HISTORIC AND DESIGN REVIEW COMMISSION

December 15, 2021

HDRC CASE NO:	2021-625
ADDRESS:	306 KING WILLIAM
LEGAL DESCRIPTION:	NCB 743 BLK 2 LOT 12
ZONING:	RM-4,H
CITY COUNCIL DIST.:	1
DISTRICT:	King William Historic District
APPLICANT:	Juan Barrera
OWNER:	Juan Barrera/MATTA-BARRERA ROMANITA & JUAN A BARRERA
TYPE OF WORK:	Exterior modifications to rear accessory structure
APPLICATION RECEIVED:	November 22, 2021
60-DAY REVIEW:	Not applicable due to City Council Emergency Orders
CASE MANAGER:	Stephanie Phillips

The applicant is requesting a Certificate of Appropriateness to enclose an existing carport extension on the rear accessory structure and install two single bay garage doors.

Proposed installation of two garage doors

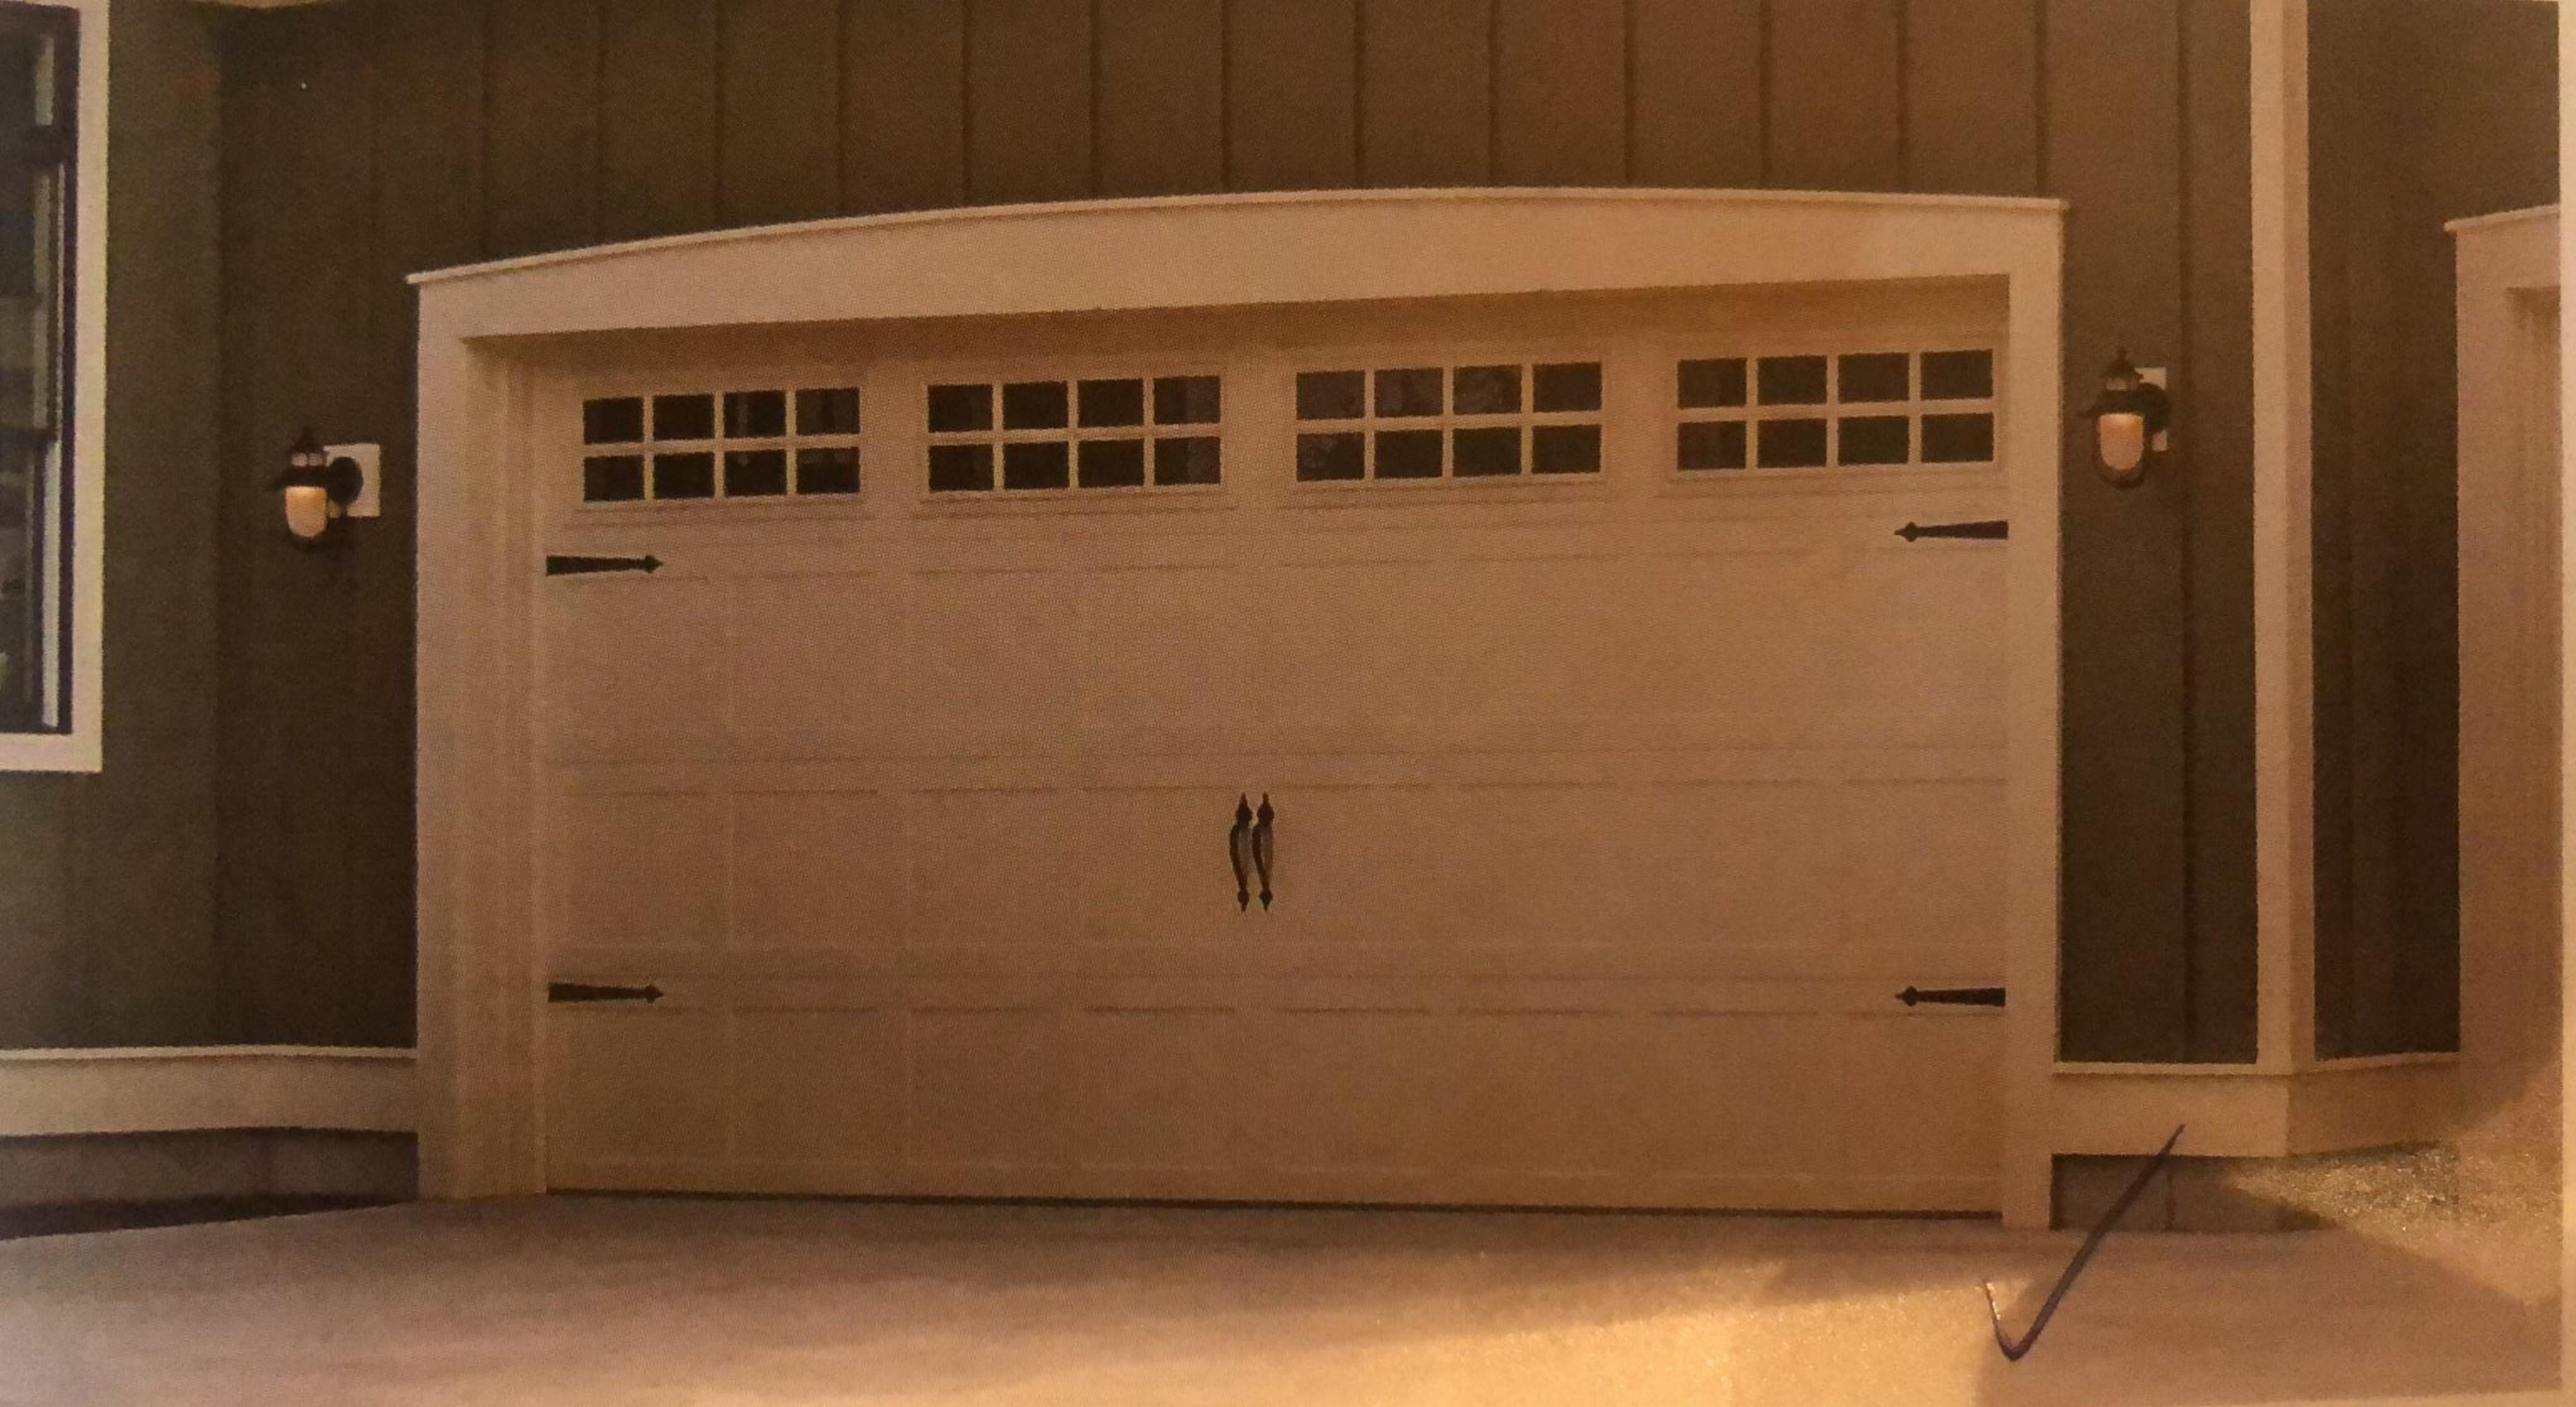
- b. REAR ACCESSORY STRUCTURE MODIFICATIONS – The applicant has proposed to enclose an existing carport extension on the rear accessory structure and install two single bay garage doors. The existing carport portion is not original to the site based on Sanborn Maps. The carport will be enclosed with wood and will feature single bay garage doors. The overall footprint and roof form will not be modified, though existing non-original architectural details that mimic Folk Victorian gingerbread will be removed. Per the Guidelines, when new materials are needed on outbuildings, they should match existing materials in color, durability, and texture. Ensure that garage doors are compatible with those found on historic garages in the district (e.g., wood paneled) as well as with the principal structure. Updates to rear structures should be based on the architectural style of the primary building and historic patterns in the district. Staff finds the proposal consistent with the Guidelines based on the non-original nature of the carport, the compatibility of the enclosure design and materiality, and the double bay garage doors. Staff finds that the garage doors should be fully wood or feature a design that mimics wood construction and features a smooth finish without a faux wood grain texture.

- i. That the applicant installs a fully wood garage door or a garage door with a design that mimics wood construction and features a smooth finish without a faux wood grain texture. Final garage door specifications must be submitted to staff for review and approval prior to the issuance of a Certificate of Appropriateness.
